# Access Compliance Report

## Public Rights-of-Way

### (Curb Ramps)

Intersection ID: 10040845	Main Street: WAKEFIELD_DR	Cross Street: N/A	Location: E
ADA ID: 83956E5D51AD	Ramp Type: PerpDiag	Initial Pass/Fail: Fail	Overall Compliance: No
Severity Score: 25			
Codes/Mitigation Info/Possible Solution		Field Measurements/Component Compliance

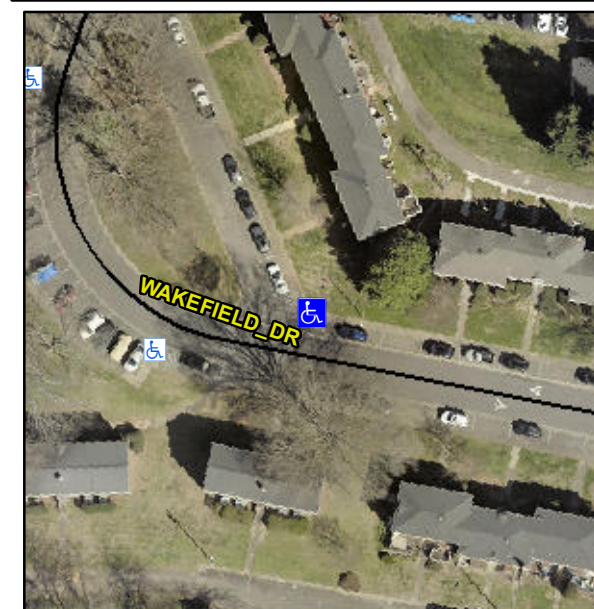
**Not Found, R304.5.3**

Compliance	Description	Data	Compliance	Description	Data
N/A	Ramp Length (in)	60.0	Yes	Ramp Slope (%)	5.5
Yes	Ramp Width (in)	48.0	No	Ramp XSlope (%)	9.8
N/A	Flare Type LT	N/A	N/A	Flare Type RT	N/A
N/A	Flare Slope LT (%)	N/A	N/A	Flare Slope RT (%)	N/A
N/A	Flare Traversable LT?	N/A	N/A	Flare Traversable RT?	N/A
N/A	Landing Length (in)	N/A	N/A	DWS Provided?	N/A
N/A	Landing Width (in)	N/A	N/A	DWS Contrast?	N/A
N/A	Landing Slope (%)	N/A	N/A	DWS Length (in)	N/A
N/A	Landing X Slope (%)	N/A	N/A	DWS Full Width?	N/A
N/A	Landing Curb? (Y/N)	N/A	N/A	DWS Offset (in)	N/A
N/A	Shared Landing?	N/A			
N/A	Gutter Ponding?	N/A	N/A	Gutter Slope (%)	N/A
N/A	Gutter Lip Ht (in)	N/A	N/A	Gutter X Slope (%)	N/A
N/A	Painted X Walk1?	No	N/A	Painted X Walk2?	No
	X Walk 1 Direction	To W		X Walk 2 Direction	To S
N/A	X Walk 1 Width (in)	N/A	N/A	X Walk 2 Width (in)	N/A
	X Walk 1 Slope (%)	5.5		X Walk 2 Slope (%)	9.1
	X Walk 1 X Slope (%)	5.2		X Walk 2 X Slope (%)	7.1

**Remove & Replace Curb Ramp With Two New Directional Ramps or Equivalent.**
